DESIGN REVIEW BOARD MARCH 20, 2020

ALPHARETTA CITY HALL
COUNCIL CHAMBERS
2 PARK PLAZA
8:30 AM

- VII. PUBLIC HEARING
 1. 09:10 - 09:30 North Point Eco Guidelines
Kathi to discuss North Point Guidelines
 2. 09:30 - 09:40 DRB200011 SP&G Attorneys 284 North Main St
review signage

3. 09:40 - 10:10 DRB190054 The Felix School 500 Arts Summit
review exterior revisions
 4. 10:10 - 11:00 DRB190028 Lazy Dog 10800 Haynes Bridge
review new construction

DD4.0

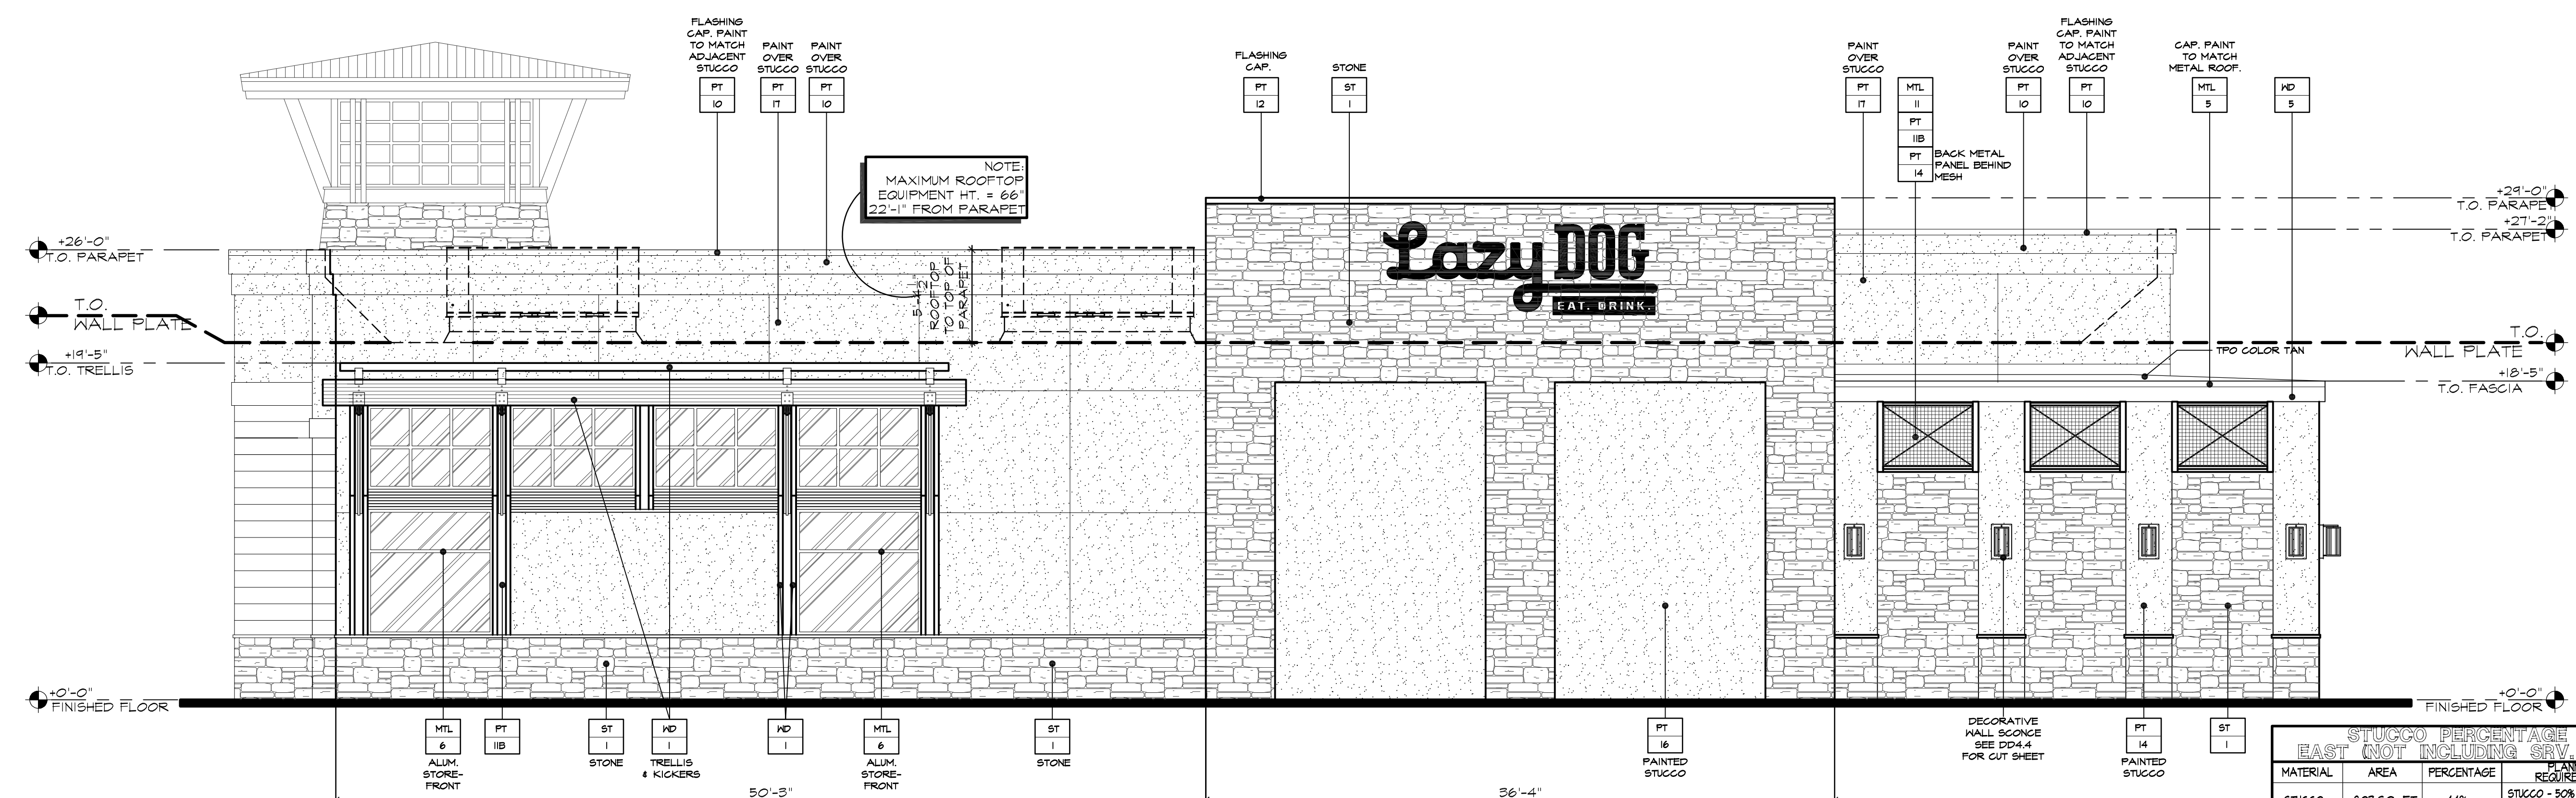
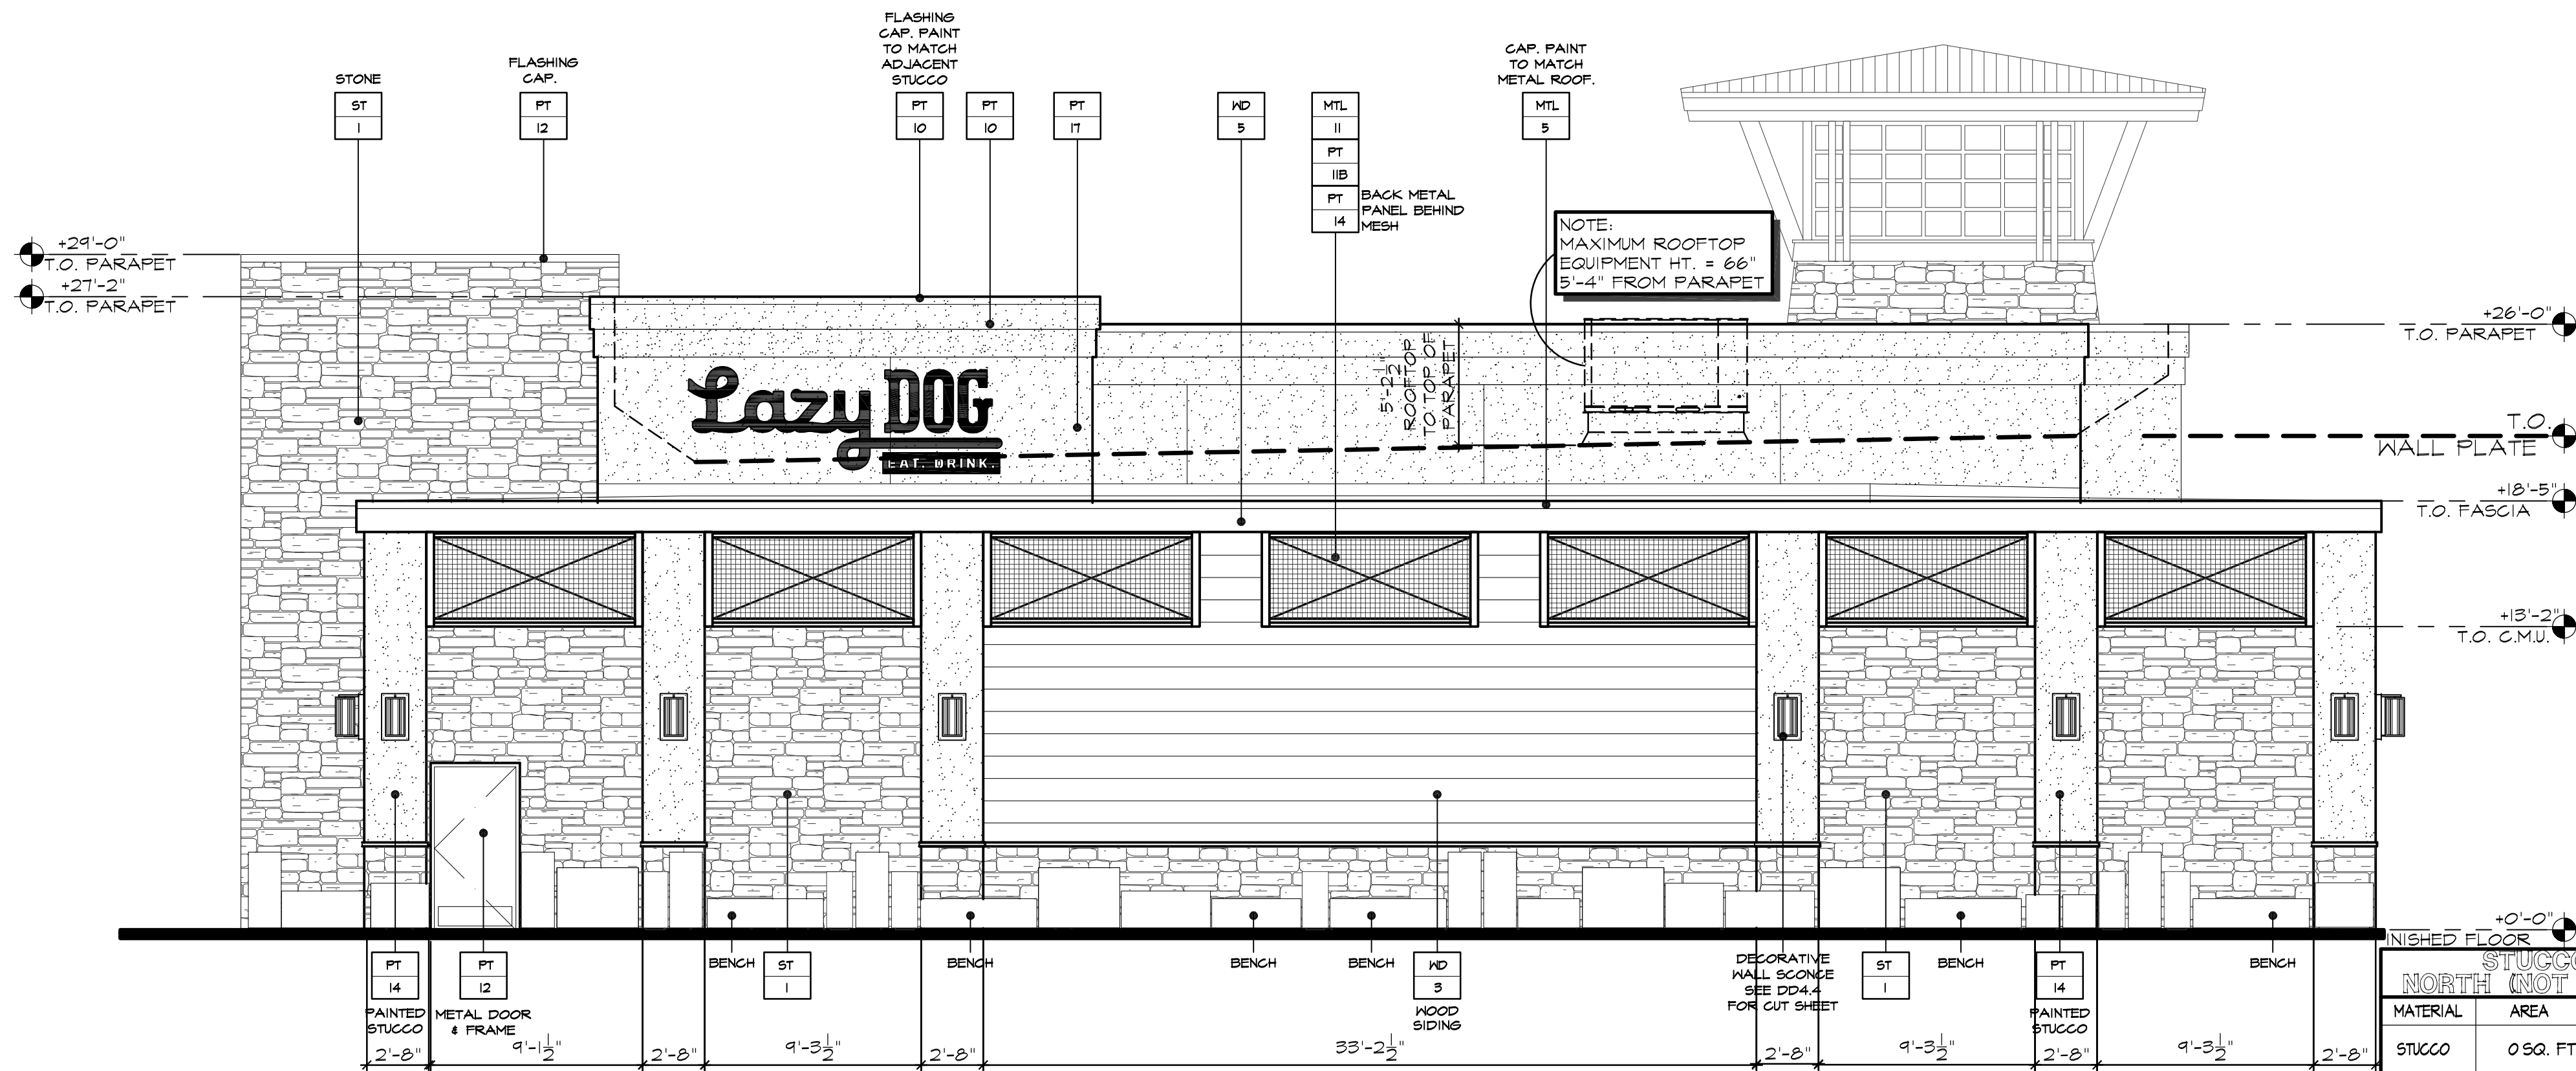
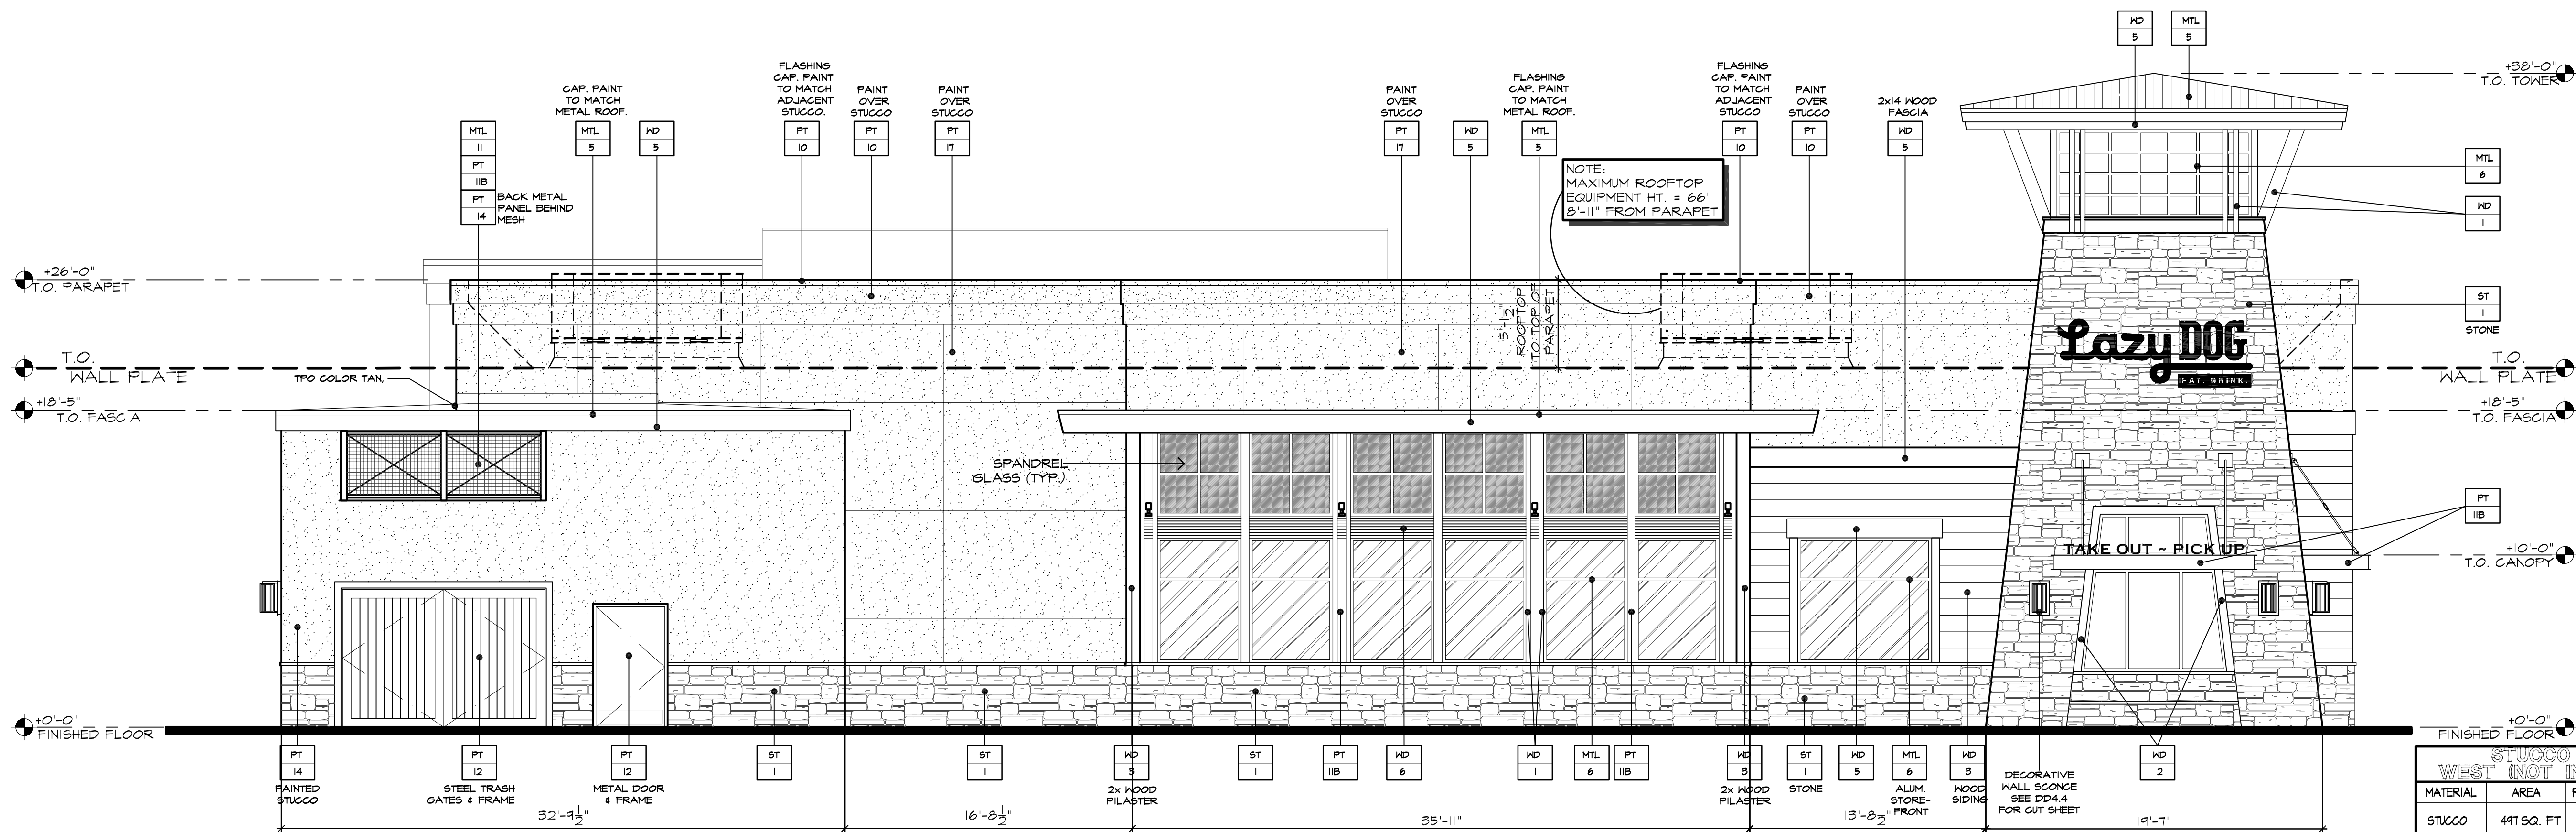
4. On large expanses of any material it should be broken up by details - See sheets DD4.0 & DD4.1
5. Detectable barrier needed on all 3 sides of patio – Patio currently has a railing around the patio as well as columns and planting areas.

9. Site line study from several areas along the R/W showing RTU's is required – See sheet DD4.3 & DD4.3A
10. maximum 50% stucco on any elevation (not including parapet, maybe) – See sheet DD4.0 & DD4.1 for stucco percentages

- Revised east elevation to add more glazing & remove CMU from service yard.
- Added stucco calculation
- Add dimension stringers to elevations to note there isn't a 60' span without design elements.

STUCCO PERCENTAGE EAST (NOT INCLUDING SRV. YD)			
MATERIAL	AREA	PERCENTAGE	PLANNING REQUIREMENTS
STUCCO	803 SQ. FT	44%	STUCCO - 50% MAXIMUM (TO TOP OF WALL PLATE) - SERVICE YARD NOT PART OF BUILDING CALCULATION

STUCCO PERCENTAGE EAST (INCLUDING SRV. YD)			
MATERIAL	AREA	PERCENTAGE	PLANNING REQUIREMENTS
STUCCO	935 SQ. FT	40%	STUCCO - 50% MAXIMUM (TO TOP OF WALL PLATE)
